# MERCURY Service bulletin

No. 99-2

▲ = Revised July 1999

# V6 and V8 305/350 cid Engines with MEFI-3

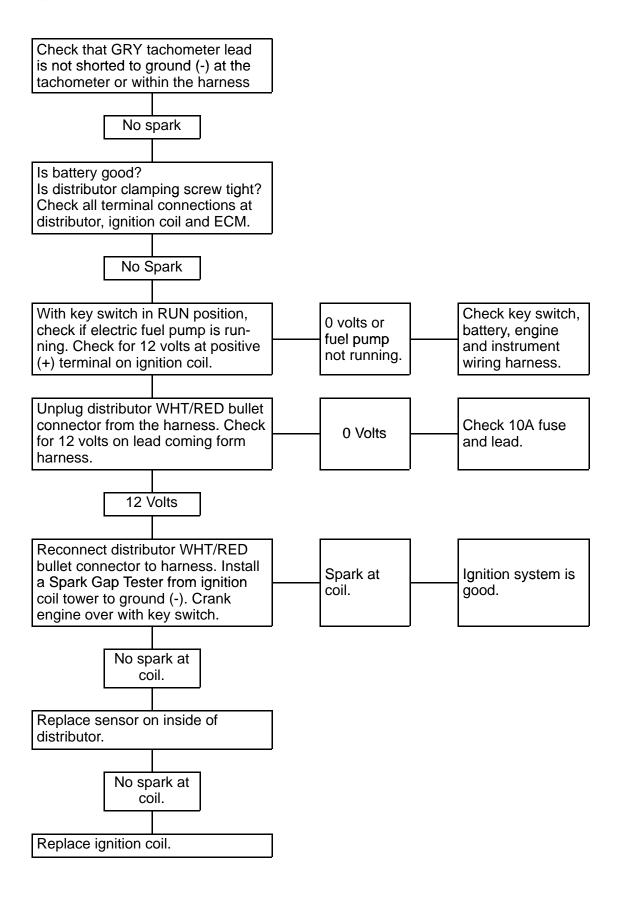
The Shift Switch shown in the wiring diagram is used on Alpha models only. The switch is normally 'closed' completing a circuit from the ECM's J2-9 terminal through the shift switch, to ground. When shifting, the switch will 'open' the J2-9 wire between the ECM and ground. This will cause the ECM to go lower the IAC motor count and retard the ignition timing to help the shifting. When the shift switch is back in the normal position, ignition timing and IAC motor count are restored.

# V6 (262 cid) and V8 (305/350 cid) MEFI 3 PAGE 1 OF 3

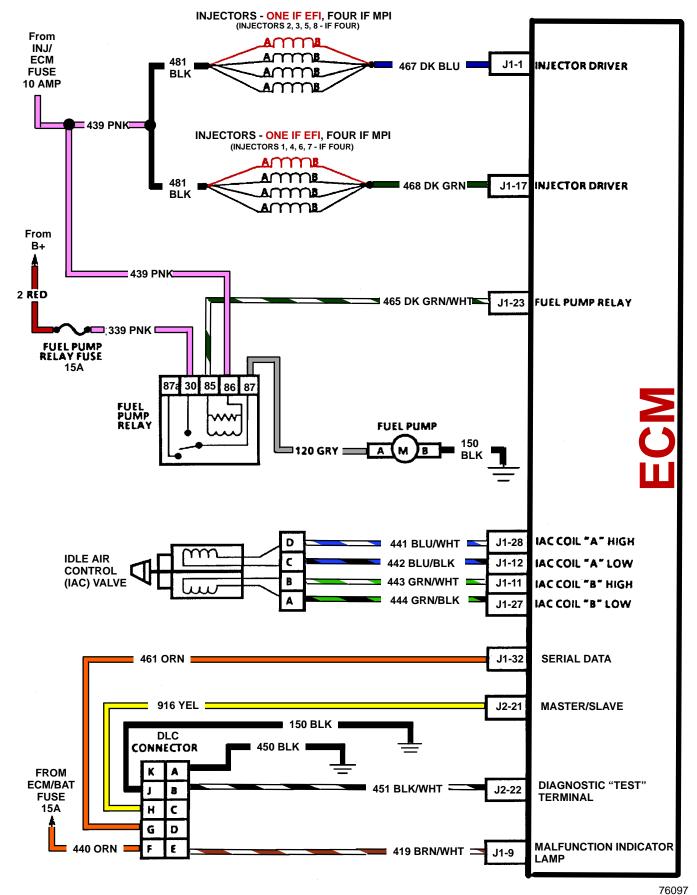
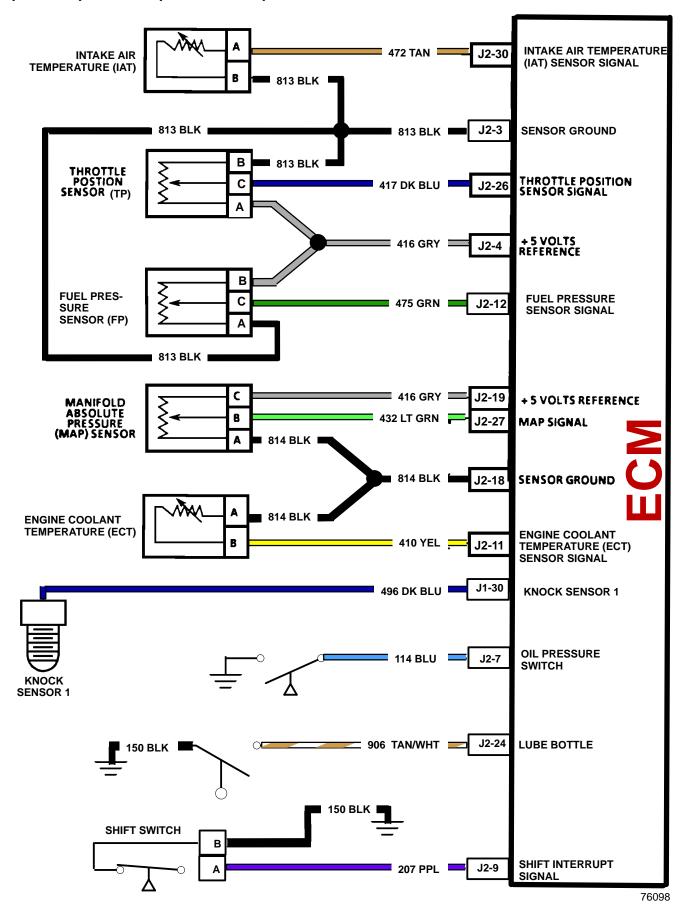
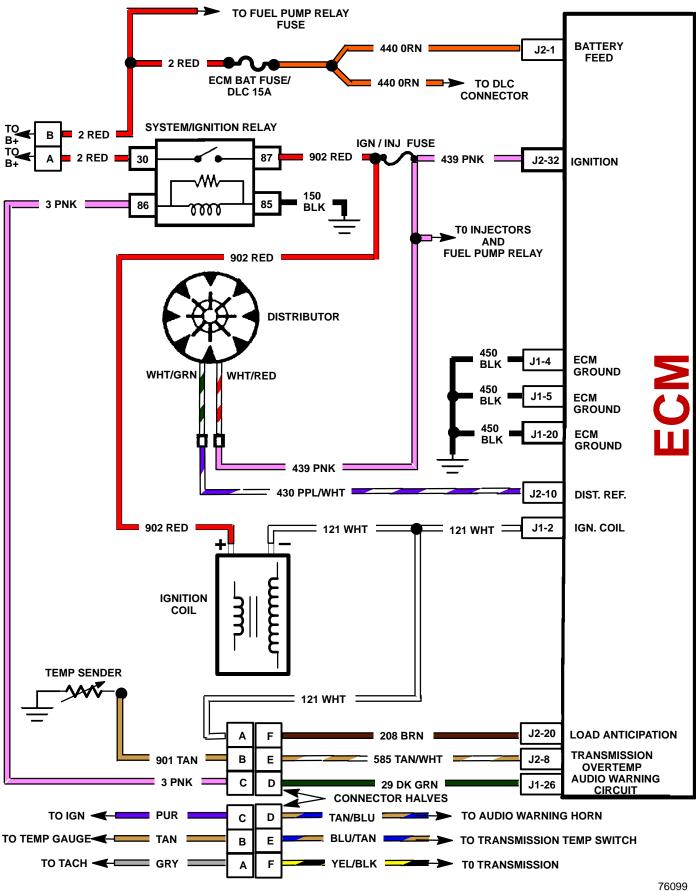
A revised MEFI-3 troubleshooting chart for these engines is in this service bulletin.
